INSPECTION REPORT

DATE OF INSPECTION: March 22, 2017

PERMITTEE - MINE: Dakota Westmoreland Corporation (DWC) - Beulah Mine

PERMITS INSPECTED: KRSB-8603 and KRSB-8802

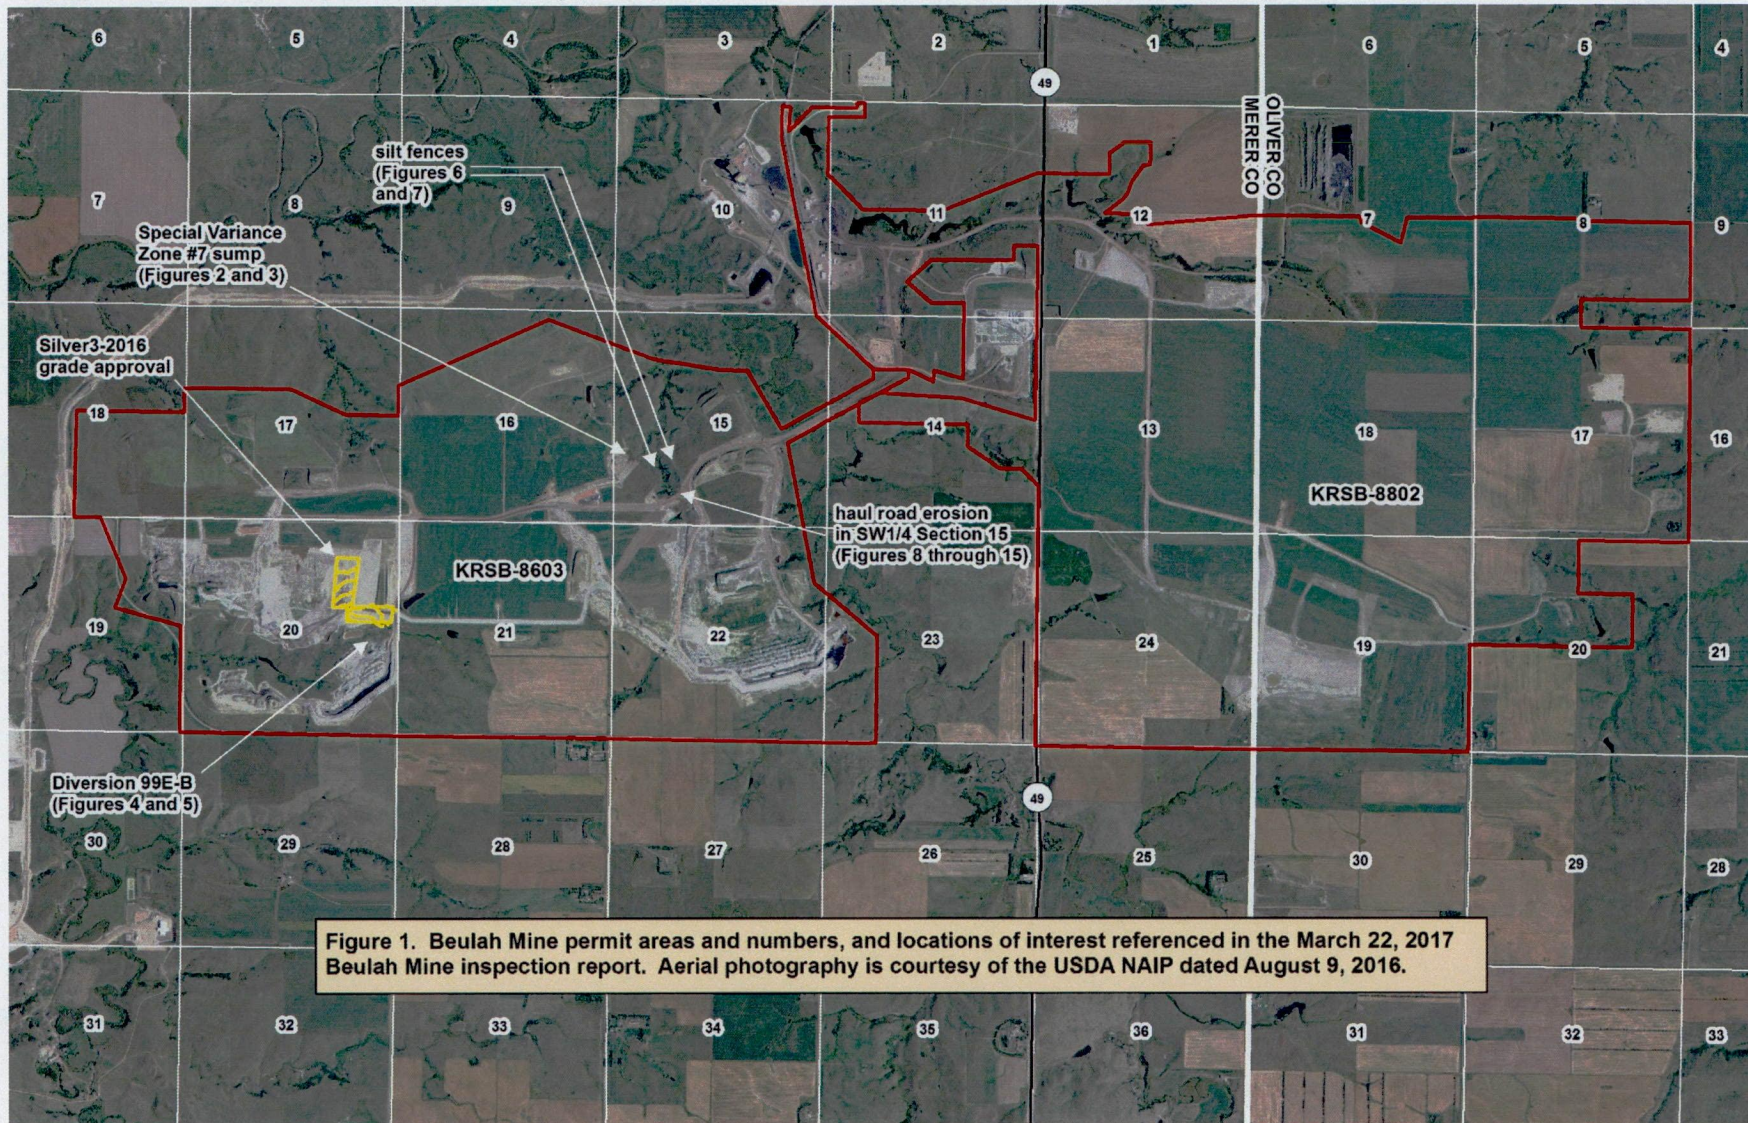
The sump in Special Variance Zone #7 (spoil stockpile to reclaim Pond 86 and its associated sump that also contains haul road runoff) located in the NW¼SW¼ of Section 15 was viewed during the inspection. Please refer to Figures 1 and 8 for the sump location. It appeared that the spoil stockpile sump overflowed and cut down to an adjoining linear sump to the north that was apparently installed to detain runoff from reclaimed land for which ten-year revegetation period was initiated in 2010 as pictured in Figure 2. It also appeared that comingled sump drainage flowed through a silt fence to the undisturbed intermittent stream bank in the NW¼SW¼ of Section 15 as pictured in Figure 3. Runoff detained in the spoil stockpile and haul road runoff sump must be pumped to Pond 86 as specified on page 3.8.8 of the KRSB-8603 permit rather than being discharged through a silt fence.
